Product Change Notification / RMES-10YAUB493

CCB 4898 and 4898.001 Final Notice: Qualification of a new die size for Die # 2 for selected catalog part numbers (CPN) SAM9X60D1G-I/4FB, SAM9X60D1GT-I/4FB, SAM9X60D5M-I/4FB, SAM9X60D5MT-I/4FB available in 233L TFBGA (14x14x1.2mm) and U2 component for selected catalog part number (CPN) SAM9X60D1G-I/LZB available in 152L MODULE (28x28x2.4mm) packages.

CCB 4898 and 4898.001
Pre and Post Change Summary
PCN#: RMES-10YAUB493

Die # 2 Location

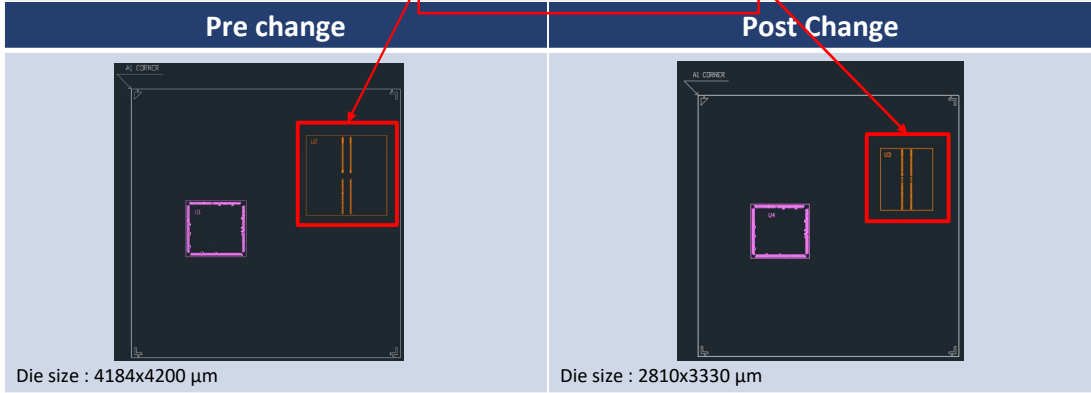
DDR2 -1Gb

Note: Not-to-scale

Location of Die Size Change

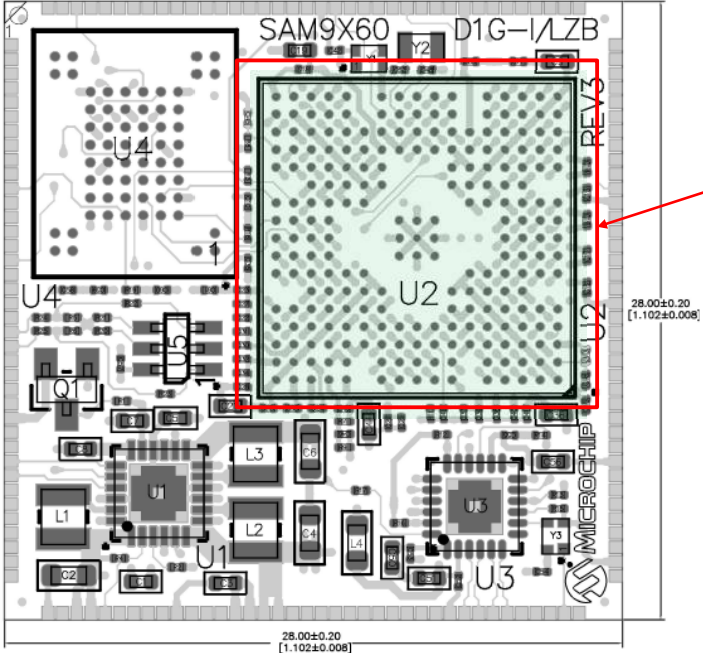
DDR2 -512Mb

Note: No change in U2 component location
